Editorial changes since 1st meeting of Drafting Group, 21 November 2017

Proposal for determination of system power of hybrid vehicles or pure electric vehicles having more than one electric machine for propulsion for use with the Worldwide harmonized Light vehicles Test Procedure (WLTP)

Draft proposal for determination of system power of hybrid vehicles or pure electric vehicles having more than one electric machine for propulsion

Figure 2 — Relation between power and speed

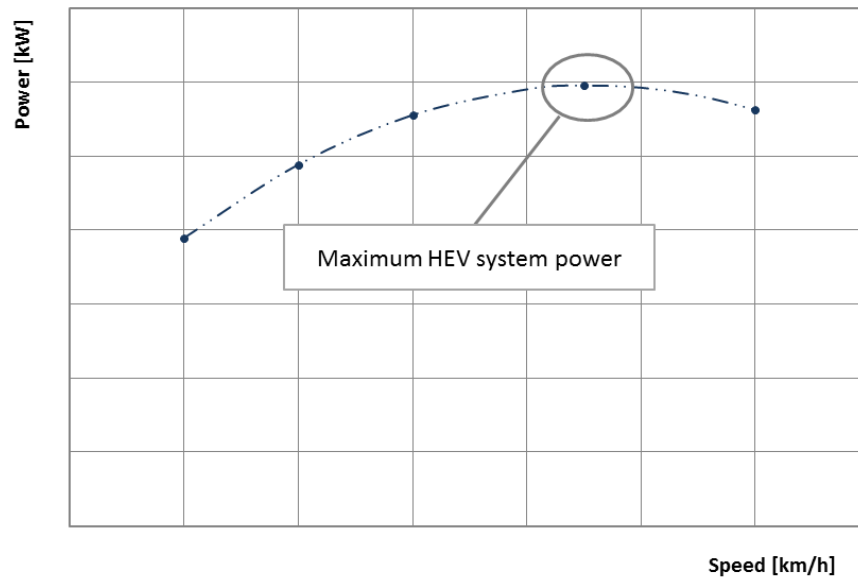
- Clause 7 restructured to separate discussion of TP1 and TP2.
- Equations in Annex A reformatted with Word equation editor.
- TP1 and TP2 added to definitions and abbreviations.
- Updated Figure 3 to show REESS instead of RESS
- Updated Figure 2 to remove extraneous green lines at border

Figure 3 — Test sequence for determination of maximum HEV system power

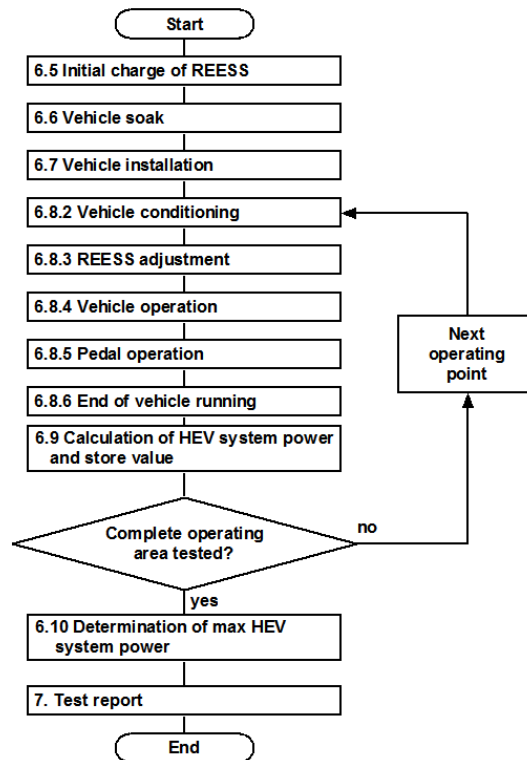
- Other miscellaneous edits to 6.9 and 7.1 to align with ISO FDIS 20762
- Updated Figure 3 per ISO FDIS 20762
- Updated Figure A.2 per ISO FDIS 20762 and minor edits to related formulas
-
